REFERENCE:	Nova Bus Manuals
SECTION:	12: Interior Furnishing
RS N°:	MQR 7621-1007
EFFECTIVE IN PROD.:	N/A

SUBJECT:	Articulation stanchion
JUSTIFICATION:	New improved stanchion is now available for installation in the articulation section of the vehicle.

Figure 3 - Removal of Stanchion

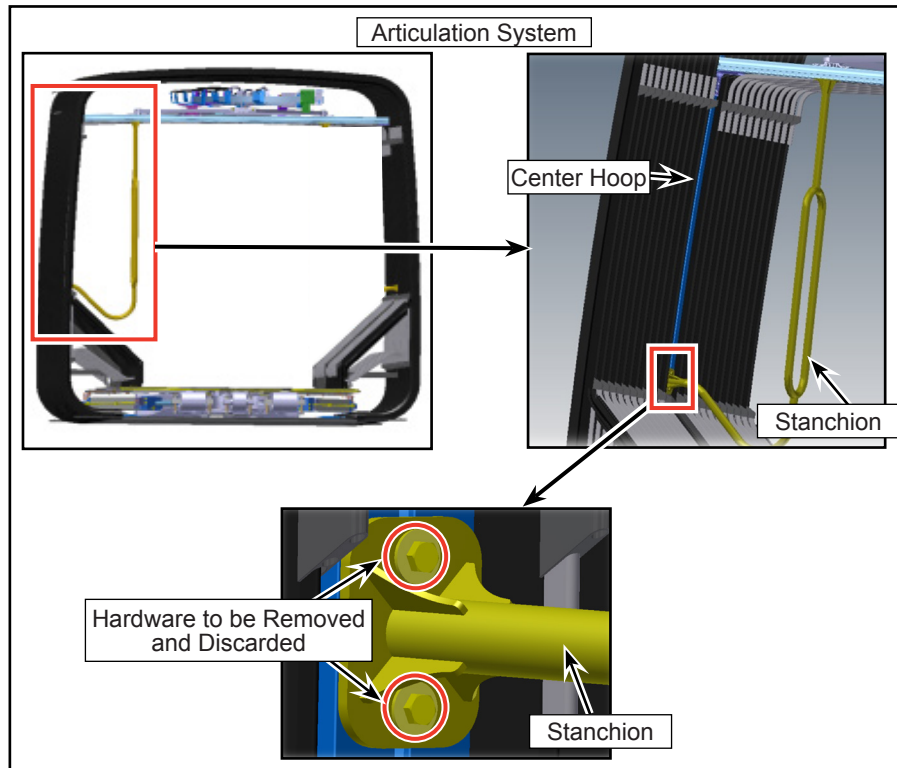
- 1.4. Remove the existing stanchion fixed to the center hoop of the articulation. Discard the stanchion, bolts and washers (see Figure 3).

Figure 5 - Installation of Tenon Block

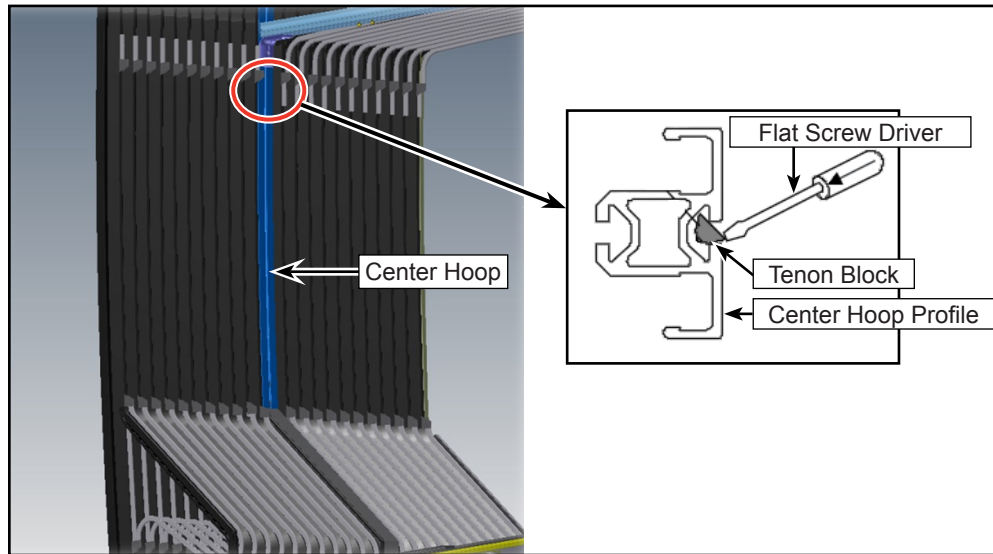
- 1.6. Install the new tenon block into the center hoop profile (right below the horizontal guiding profile) with a flat screw driver as shown (see Figure 5).

Figure 6 - Installation of New Stanchion

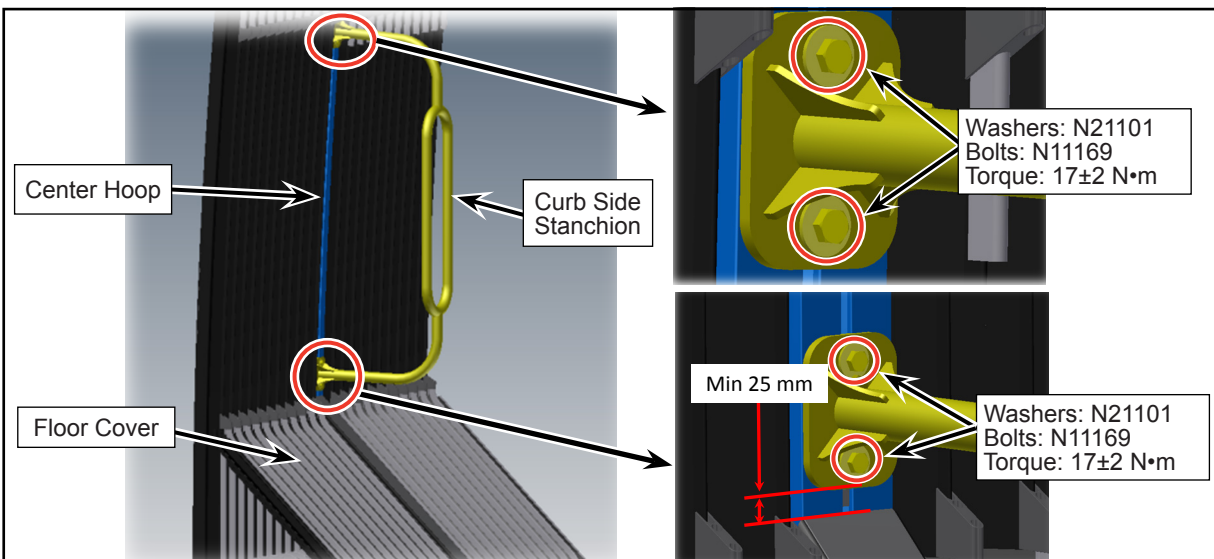
- 1.7. Install the new stanchion on to the tenon block present inside the center hoop profile with the hardware provided. Ensure that the new stanchion provided is installed on curb side of the bus (see Figure 6).
- 1.8. Ensure that enough gap (Min. 25 mm) is left between the lower edge of the stanchion and the floor cover profile as shown (see Figure 6).
- 1.9. Apply blue thread locker and torque the bolts as specified (see Figure 6).

Figure 7 - Typical View of Stanchion Orientation

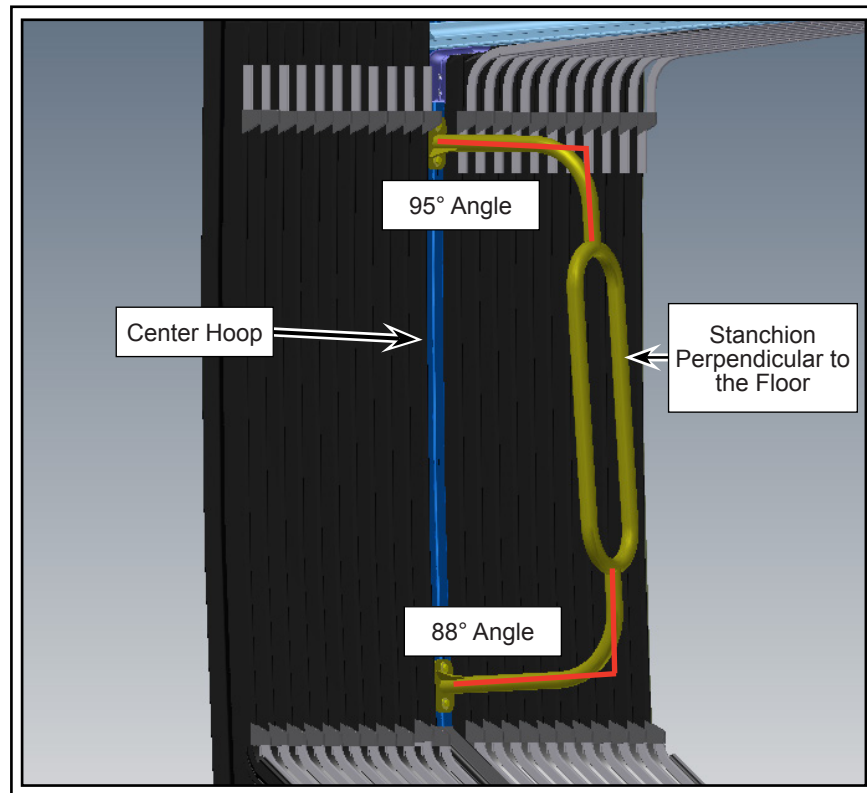
- 1.10. Ensure that the stanchion is vertical (perpendicular to the floor) (see Figure 7).
